Site 9 Sydney Olympic Park, 3 Olympic Boulevard proposed residential development. Expert Judgement related to BASIX alterations

The architectural drawings that were reviewed as part of amendment are the Bates Smart Architectural drawing series DA.01 Revision B. These drawings have been attached to this letter.

Attachment- Bates Smart Architectural drawing series DA.01 Revision B

General Arrangement Plan
Level 09

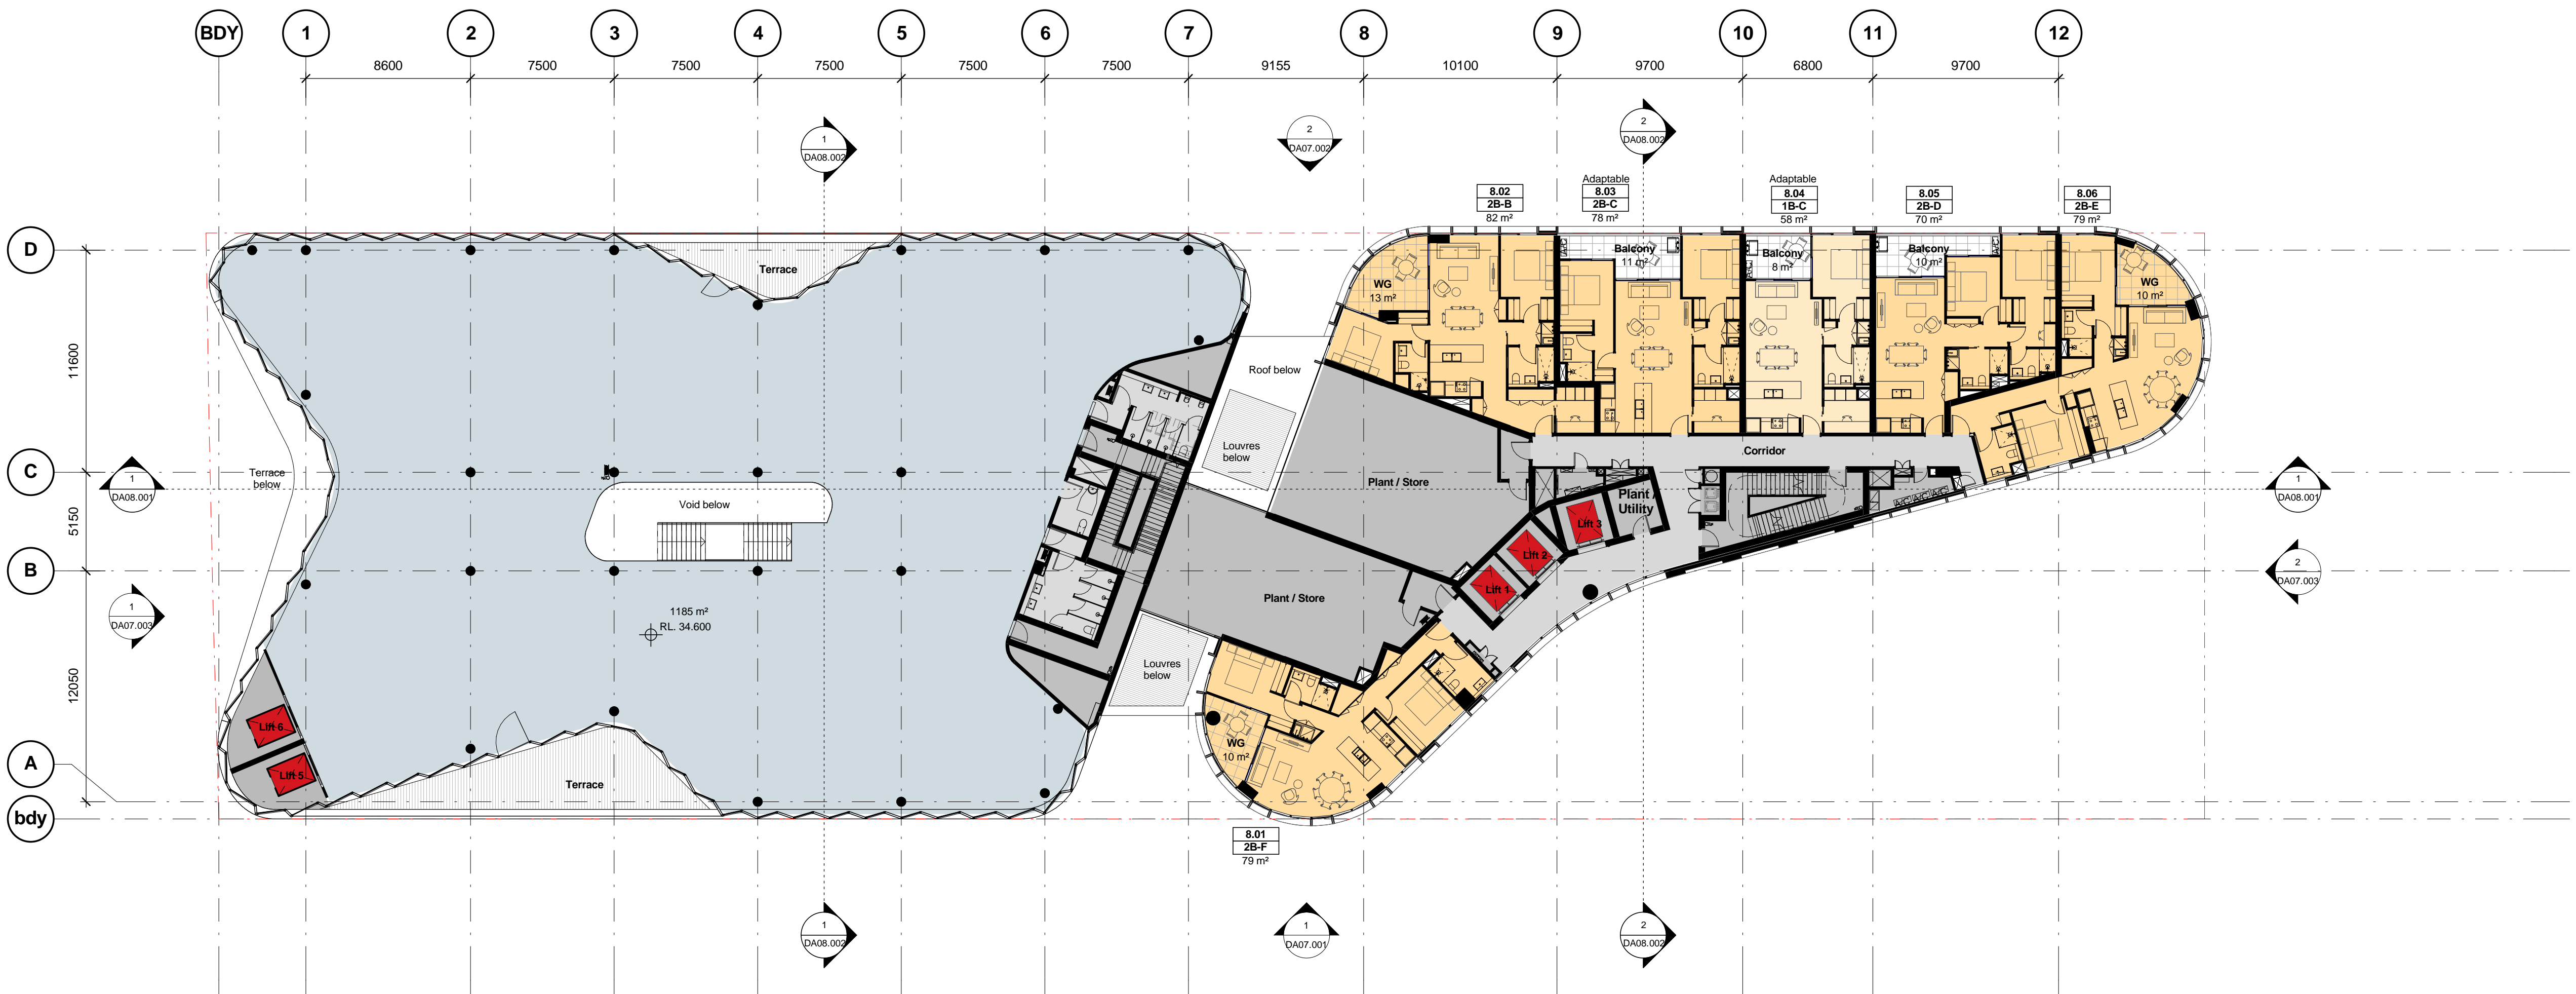
- 1. Level 39 penthouse** – A new 270m² four bedroom apartment accessed via stairs off Level 38.
- 2. Level 9** – Deleted 1 north-facing 2-Bedroom facing communal garden to accommodate bicycle store (relocated from Ground Floor).

- The large overhang shade on the north elevation will allow the penetration of welcome winter sun but will eliminate summer sun.
- The glazing for the façade will need to be a low e double glazing potentially with thermal breaks to improve the overall U value of the façade system. The solar performance (SHGC) of the glass will need to be assessed but we believe it will be a realistic range of SHGC 0.3 to 0.5.
- The deletion of the one north facing apartment to accommodate bicycle storage will not impact the overall BASIX performance.
